Lawrenceburg Community Center

ADDENDUM 2

Addendum No. 2

Project Name: Lawrenceburg Community Center Renovations
Project Number: 2022.01820
Date: 04.15.2024

Alternate No. 1A - Decorative Concrete in Lieu of Standard Broomed Finish at ADA Walk-Way (Approximately 250SF)

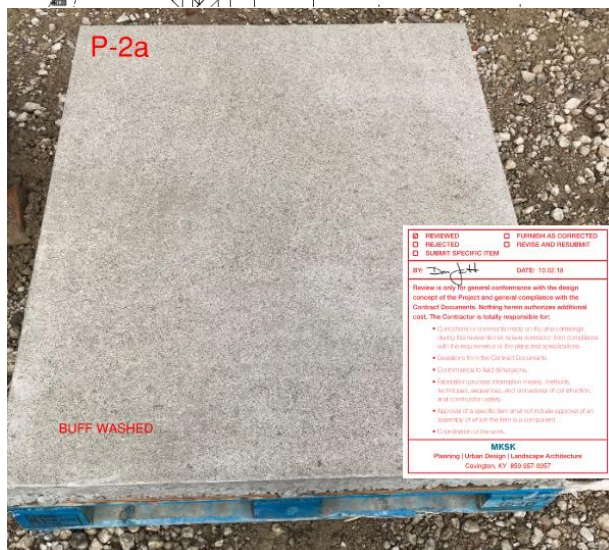
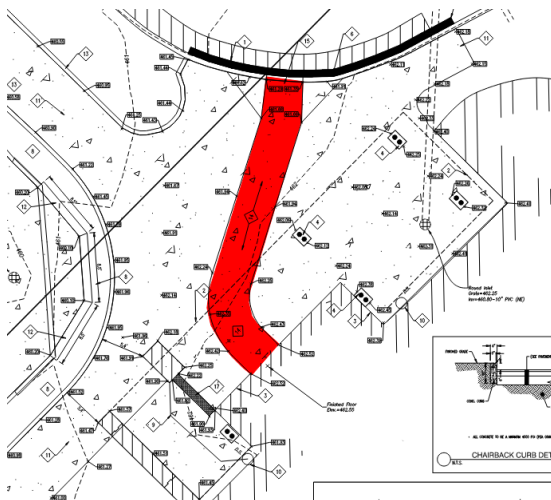
- Description: Base-bid for all site concrete to include standard broomed finish for all site-concrete including tooled joints, picture framed borders, and caulked construction joints.
- Alternate #1A to include ADD for exposed aggregate buff-wash finish to match what is at Lawrenceburg Civic Park per picture below, in lieu of broomed finish concrete as specified at ADA path from ADA Ramp to Front Door as shown in area in Red below per Sheet C-101. (Mock-up to be provided onsite on a 4'x4' pallet that is to be retained until work is complete.)

Alternate No. 1B - Stamped Concrete in Lieu of Standard Broomed Finish at ADA Walk-Way (Approximately 250SF)

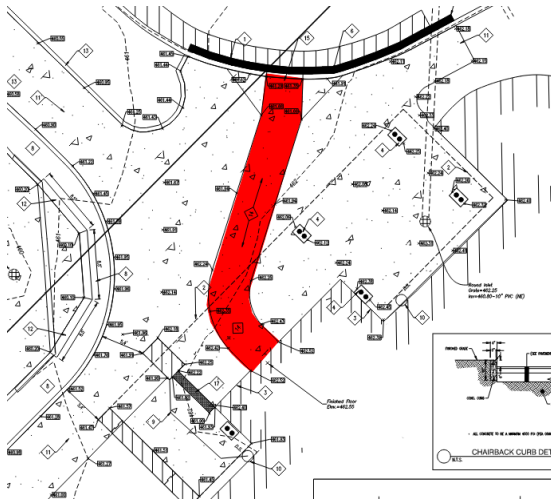
- Description: Base-bid for all site concrete to include standard broomed finish for all site-concrete including tooled joints, picture framed borders, and caulked construction joints.
- Alternate #1B to include ADD for slate pattern (light texture) w/ one plant dosed integral color and single powder colored release agent at ADA path from ADA Ramp to Front Door as shown in area in RED below. **For the plant dosed integral color, include Allowance of \$150/CY for coloring.** (Mock-up to be provided onsite on a 4'x4' pallet that is to be retained until work is complete.)

Alternate No. 2B - Stamped Concrete in Lieu of Standard Broomed Finish Under Canopy (Approximately 750SF)

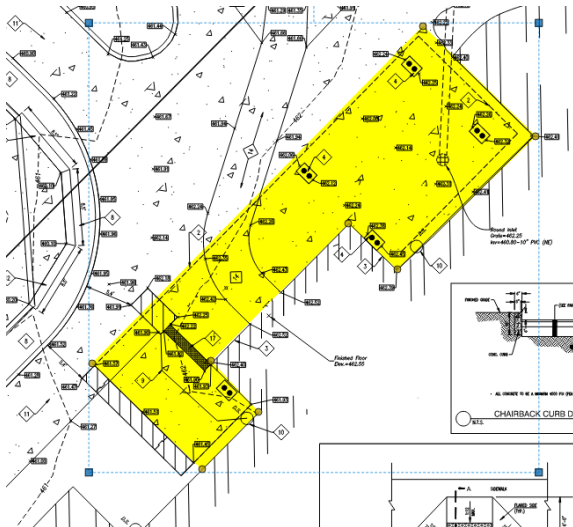
- Description: Base-bid for all site concrete to include standard broomed finish for all site-concrete including tooled joints, picture framed borders, and caulked construction joints.
- Alternate #2B to include ADD for slate pattern (light texture) w/ one plant dosed integral color and single powder colored release agent in lieu of broomed finish concrete as specified under Front Canopy as shown in area in Yellow below per Sheet C-101. **For the plant dosed integral color, include Allowance of \$150/CY for coloring.** (Mock-up to be provided onsite on a 4'x4' pallet that is to be retained until work is complete.)
